AGENDA
FARRAGUT MUNICIPAL PLANNING COMMISSION

December 21, 2017
7:00 p.m. Farragut Town Hall

SUBJECT: Discussion on a site plan for Kingston Pike Village, Parcels 78.03, 79, 80, and 81, Tax Map 151, 13110 Kingston Pike, west intersection of S. Watt Road and Kingston Pike, 18.59 Acres, Zoned PCD, Planned Commercial Development (GBS Engineering, Applicant)

SUBJECT: STAFF COMMENTS ON THE SITE PLAN FOR THE KINGSTON PIKE VILLAGE PLANNED COMMERCIAL DEVELOPMENT

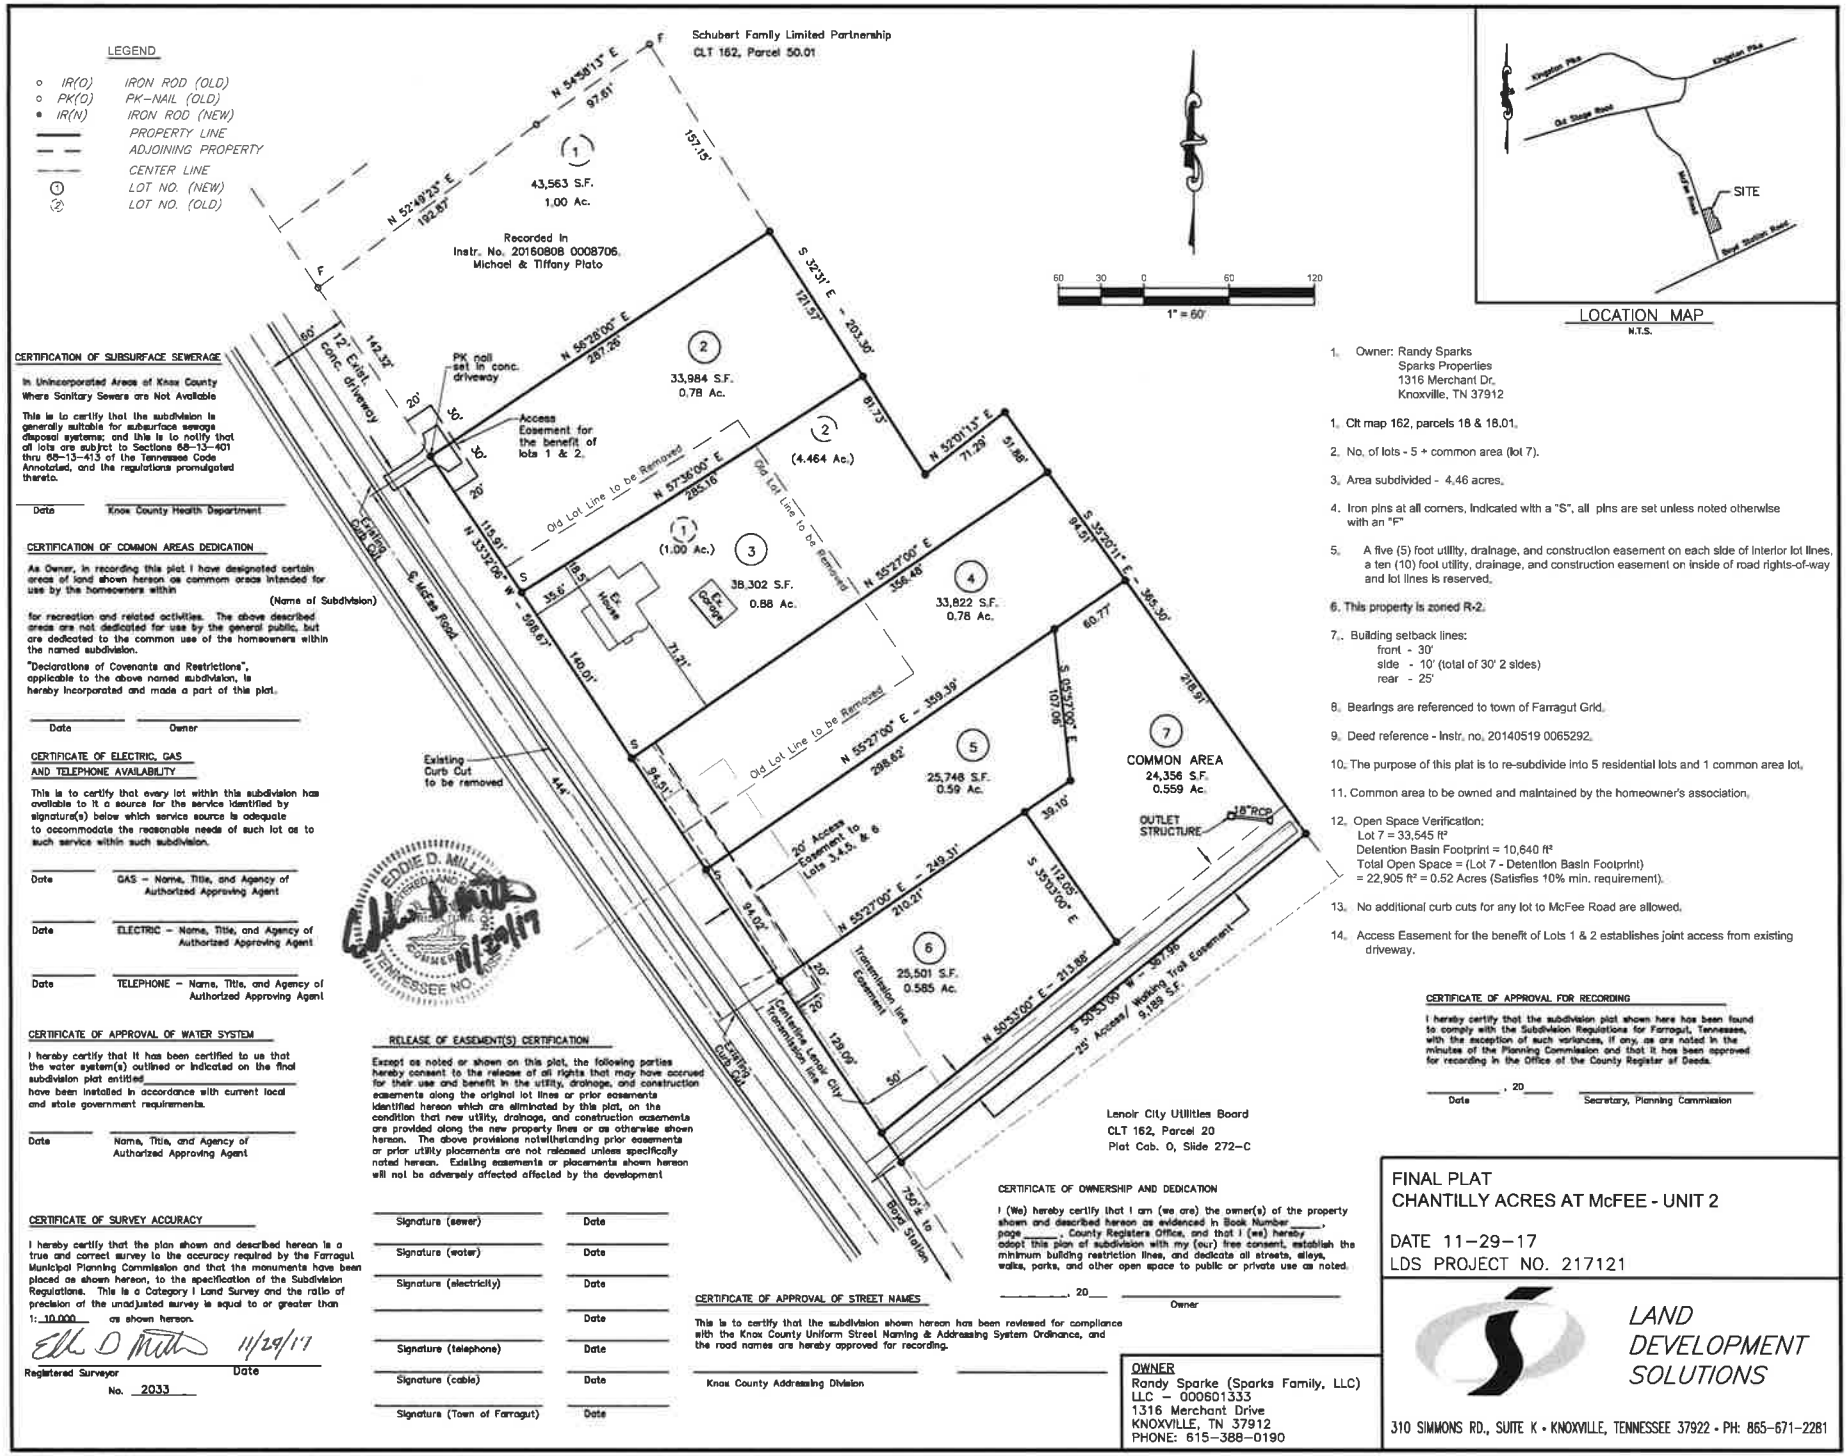
4. Please label the access easement for the benefit of Lots 1 and 2 and include a note which indicates that this easement establishes a joint access for Lots 1 and 2. No additional curb cuts for these lots is permitted onto McFee Road, please add a note clearly stating this restriction;

5. Please note that the curb cut access for Lots 3-6 must be constructed and shown on the plat. This should be done in the same way as the shared access being platted for lots 1 and 2. The existing access for Lot 3 must be removed and tied into this new access that will be shared with Lots 4, 5, and 6. Such access must be at least 400 feet from the existing joint access for Lots 1 and 2. No additional curb cuts for these lots is permitted onto McFee Road, please add a note clearly stating this restriction;
